1963 - 1964 Corvette: Service Bulletin: 3-Speed Transmission Problems

Subject: 3-Speed Transmission Problems

Source: Chevrolet Technical Service Bulletin

Bulletin No: TSB #1008 DR #676

FIGURE 2 - MAST JACKET ASSEMBLY

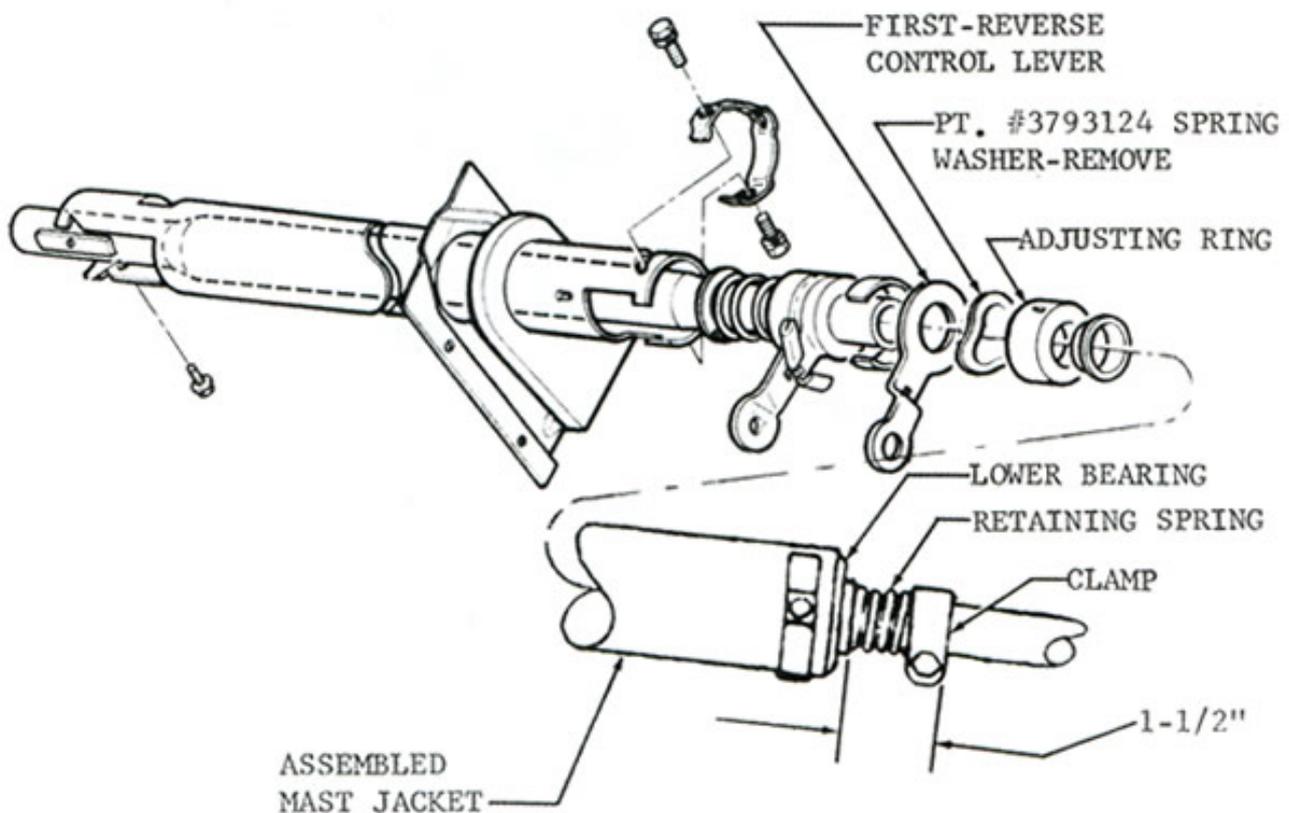
To provide a more positive shift on truck models, Part No. 3793124, transmission control 1st and reverse lever spring washer is being omitted in production and should be removed from units in service. The procedure to remove this spring washer and to readjust lever clearance is as follows:

1. Refer to Figure 2 for parts identification. Place shift lever in neutral; remove access cover from fender skirt.

2. Remove cap screws retaining adjusting ring to mast jacket.
3. Loosen steering shaft lower bearing retaining spring clamp.
4. Slide adjusting ring downward along steering shaft until Part No. 3793124, spring washer, is exposed. Cut and remove spring washer from steering shaft.
5. Apply lubriplate to thrust surfaces of control levers, relay lever and adjusting ring.
6. Position adjusting ring in mast jacket; align holes in ring with slots in mast jacket and install cap screws, but do not tighten.
7. Rotate adjusting ring upward until clearance of .005" exists between first-reverse control lever and ring as shown in Figure 3. Tighten cap screws.

8. Force lower bearing retaining spring clamp upward against spring tension until a dimension of 1-1/2" exists between lower bearing and clamp as shown in Figure 2. Tighten clamp bolt.
9. With transmission side cover selector levers in neutral position, adjust selector rod lengths per instructions in the appropriate shop manual to provide proper neutral cross-over. Replace access cover when adjustments are completed.

FIGURE 4 - INSTALLATION OF THRUST WASHERS IN CHEVY VAN

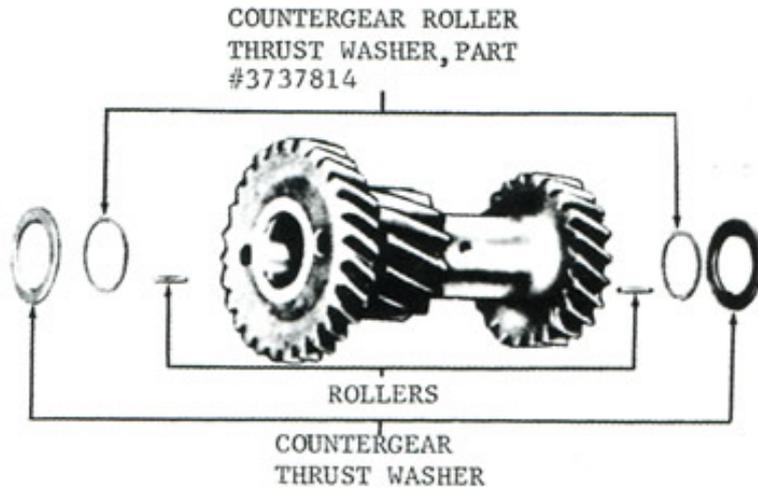
On Chevy Van models with three-speed transmissions, a small steel thrust washer is used between the countergear thrust washer and the countergear roller bearings at each end of the countergear. Since the 1964 Chevy Van Shop Manual is supplemented to the 1963 Truck Shop Manual in this area, reference to this part is omitted in error.

Figure 4 illustrates installed location of this thrust washer in Chevy Van transmissions.

FIGURE 5 - INSTALLATION OF MAGNETIC CHIP COLLECTOR

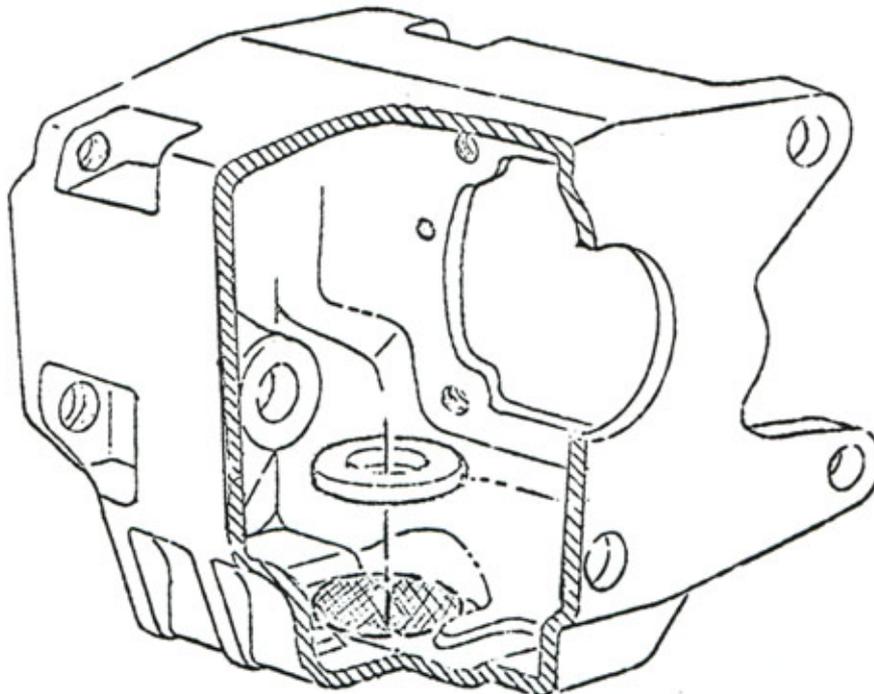
To reduce bearing noise and increase bearing durability, two changes have been released for production. First is the installation of a magnetic chip collector which went into effect on June 5, 1964. Second is the use of a new clutch gear and mainshaft bearing that incorporates a slinger ring on the inner race. This change went into effect on transmissions for use on 327 cu. in. engines on June 11, 1964, and is estimated to go into effect the week of June 22, 1964, on remaining transmissions.

Service Kit #3869240 has been released for field installation of the chip collector on 1963 and 1964 3-speed transmissions built prior to the above dates. The kit includes the magnet, cement, and instruction sheet. It also contains a 3/8 inch high pedal bumper for increasing clutch release on all except Chevy Van (Reference - Gear Clash - First and Reverse Shift). It is recommended that whenever a 1963 or 1964 3-speed transmission is disassembled for any reason, that the magnet be installed using the following procedure.

3. Wipe magnet and area in case where magnet is to be installed with Acetone or Toluol (available at most drugstores). Area where magnet is to be installed must be clean, dry and free from oil and grease film. When Acetone or Toluol is applied, be sure to use in ample quantity to neutralize grease and oil which may be in pores of casting surface. Do not touch cleaned area with hands.

4. Using cement supplied in kit, apply about a 1/16 inch thick film over entire bottom surface of magnet and immediately place in case as shown in sketch. Press straight down - do not twist while pressing in position. Note: If cement from tube appears to be thick, discard thick or hardened chunks and use cement from middle or bottom of tube.

5. To cure cement, place a trouble light with a 100 watt lamp inside of case as close to magnet as possible, and allow to stand for a minimum of 30 minutes. Use care not to touch magnet or knock it out of position. A heat lamp, if available, may be used in place of 100 watt lamp.
